WATERVIEW II METROPOLITAN DISTRICT

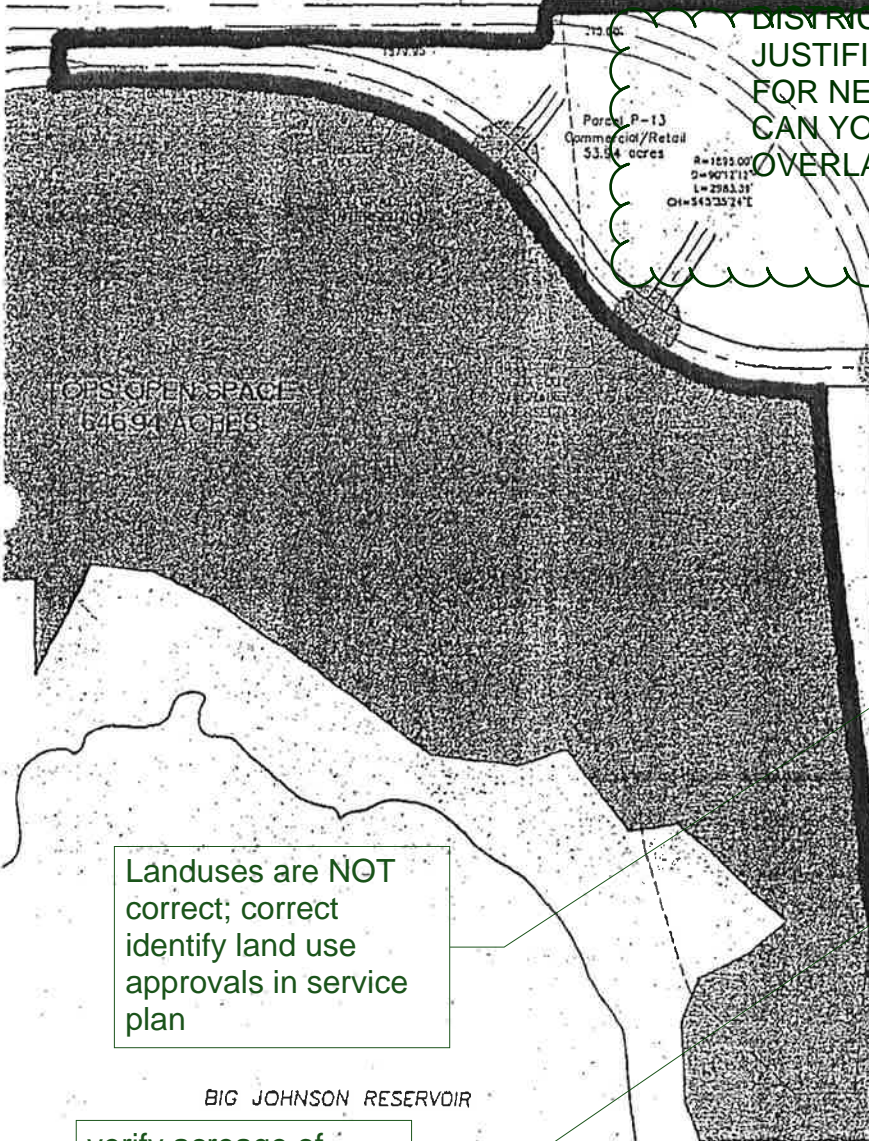
THIS ARE PROPOSED TO BE IN WATERMARK NORTH DISTRICT - WHAT IS JUSTIFICATION FOR NEED? HOW CAN YOU OVERLAP?

Landuses are NOT correct; correct identify land use approvals in service plan

verify acreage of boundary and label. Is boundary to be come smaller?
